2014 NW 57TH STREET

Design Review Analytic Design
Proposal Packet

AP Project Number: 3012980
GGLO Project Number: 2010040.00

Submitted: September 10, 2012
Meeting: September 24, 2012

URS Entry Plan

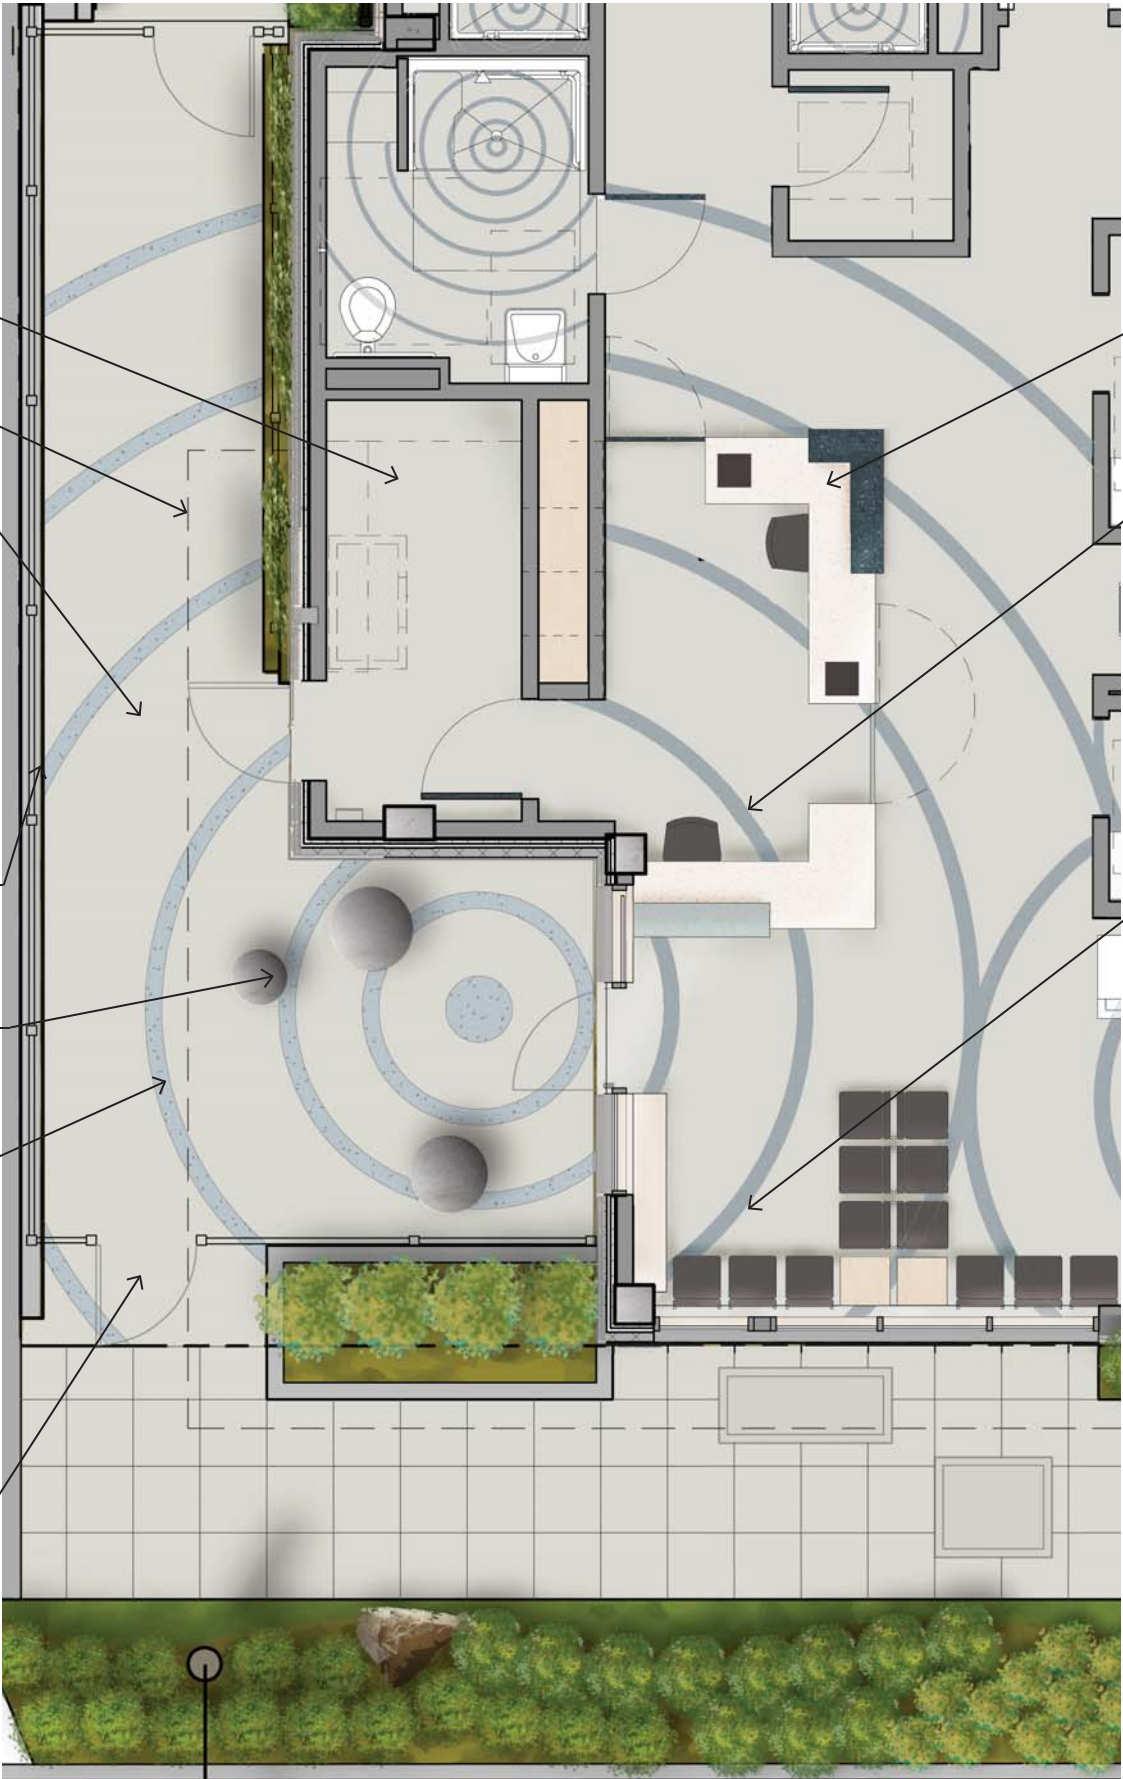
EDG Comment 14: The Board looks forward to further development of the early design concepts. Include an overhead canopy at the front entry.

Response to EDG Comment 14: Overhead canopies have been introduced at both building entries. The canopies are detailed with stained veneer plywood soffit and paired 2x10 wood members to enhance the human scale. The entry canopy at the Senior Building not only provides a sheltered area while accessing the call box, but it also serves to signify the main building entry with integrated building signage and down-lighting. The Urban Rest Stop canopy extends partially over the exterior queuing area to provide rain cover for patrons. The overhead canopy also helps to further delineate the boundary of the queuing area.

9 Finish Materials

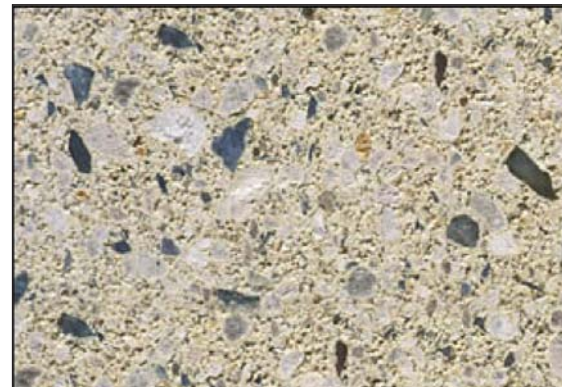
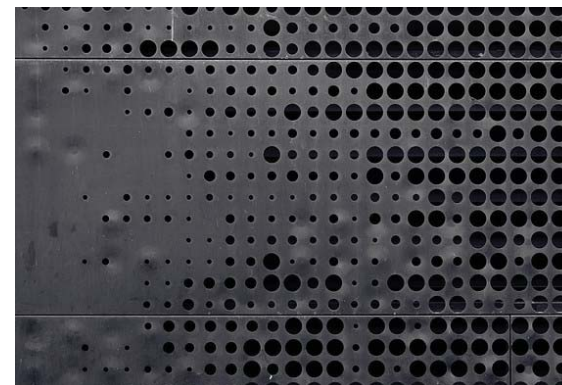
EDG Comment 13: The Board looks forward to further development of the early design concepts. The Board looks forward to reviewing detailed color and material board.

Response to EDG Comment 13: The exterior materials palette includes painted fiber cement panels with reveal joints, painted fiber cement lap siding with 7” reveal, ground face cmu, stained wood and corrugated metal roofing at the canopies, metal railings and coping, white vinyl windows, and metal storefront windows. The material palette is further enhanced with ornamental metal fencing, stained cedar fencing, colored concrete, permeable pavers, metal green screens, and granite sphere seating in the landscape design.

East Elevation

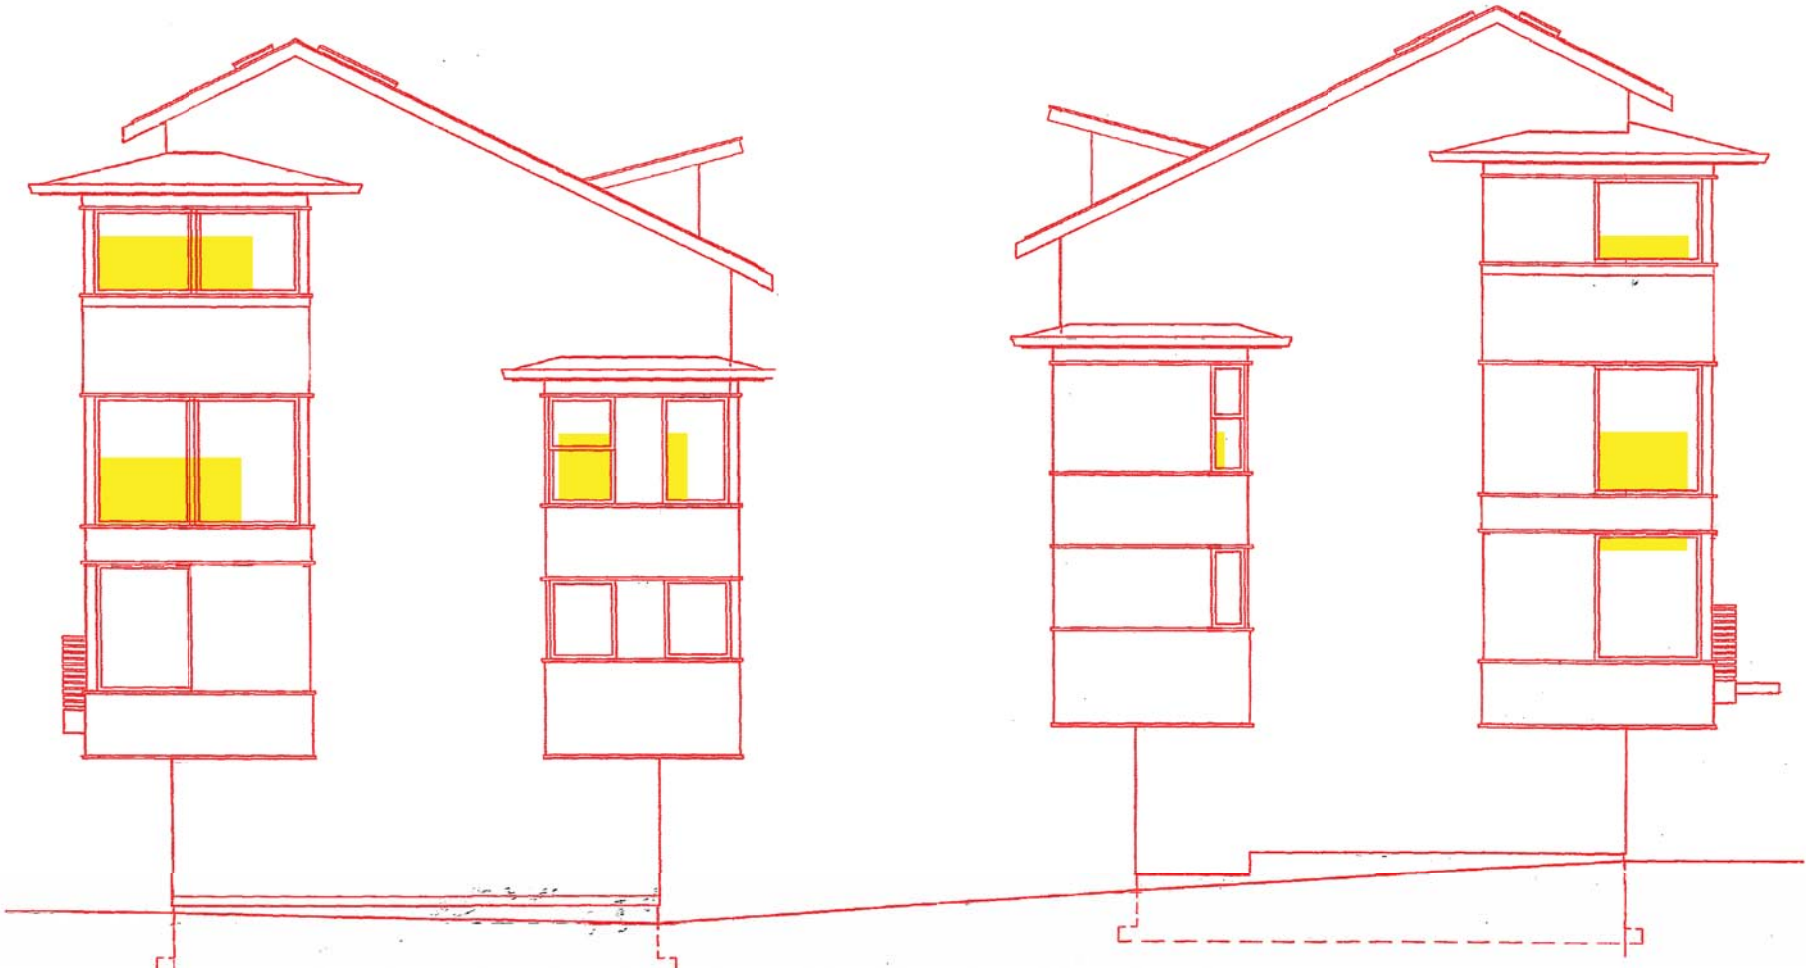
EDG Comment 2: The Board agreed that the perceived massing should be further broken down. Suggested flipping the floor plan to soften impacts to the north and east.

Response to EDG Comment 2: The upper residential levels of the building have been flipped so that only 2 apartments per floor have windows facing the east rather than the 4 apartments per floor shown at the EDG meeting. On all facades, subtly projecting building masses are attached to the main volume of the building to help break up the large facade. Contrasting colors and reveal joints in the cladding help to further break down the scale of the facade.

East Elevation Window Overlay

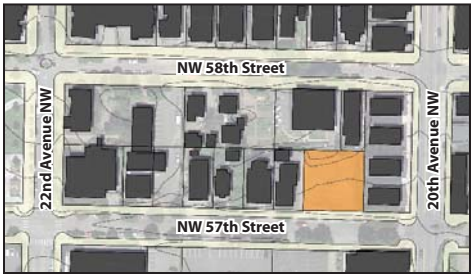
A-3	Entrances Visible from the Street	<p>Entries should be clearly identifiable and visible from the street.</p> <p>EDG Comment 8: The streetscape should be designed to enhance the pedestrian experience. Provide an exterior lighting plan that provides safety and aesthetic enhancements.</p>	
A-5	Respect for Adjacent Sites	Buildings should respect adjacent properties by being located on their sites to minimize disruption of the privacy and outdoor activities of residents in adjacent buildings.	
		<p>EDG Comment 3: The Board noted the challenge of incorporating a variety of programming within a relatively small site; sensitivity towards neighbors and locating compatible functions together and away from less compatible ones is encouraged. The design of the Urban Rest Stop should include space for queuing/waiting to occur internally with an interior waiting room, so customers are able to avoid congregating in front of the building.</p> <p>EDG Comments 7 and 9: The streetscape should be designed to enhance the pedestrian experience. (7) Shift more trees and vegetation to the SE corner in the side yard to create better screening and privacy buffers between buildings. (9) Fenestration should be designed to avoid direct views into neighboring units. The next meeting should include a study of the window locations of adjacent buildings and demonstrate how this has informed the proposed design.</p>	<p>Response to EDG Comment 3: The Urban Rest Stop includes an interior waiting area for as many as 14 people (12 people seated and 2 people standing). The exterior queuing area is located off of the pedestrian sidewalk and accommodates 21 people. The fence and gate around the exterior queuing area allows for a physical separation between pedestrians and neighbors and the waiting URS clients. The URS queuing area gate will be opened 30 minutes before the URS opens. During those 30 minutes 21 people can comfortably congregate with their belongings in the exterior queuing area.</p> <p>Response to EDG Comments 7 and 9: Neighbors to the east have been considered with both the landscape design and window placement. A 6’ high cedar slat fence provides ground level privacy between to the two properties. At the north end there are also 3 vine maple trees, 1 birch tree, and dense shrubs to provide increased privacy for the neighbors to the east from the bedroom and living room of the one apartment on level one of the Senior Building. At levels 2 through 4 window locations were carefully considered to avoid direct eye level visual access from the Senior Building windows to the windows of the east neighbors. Please see the East Elevation Window Overlay diagram for analysis.</p>
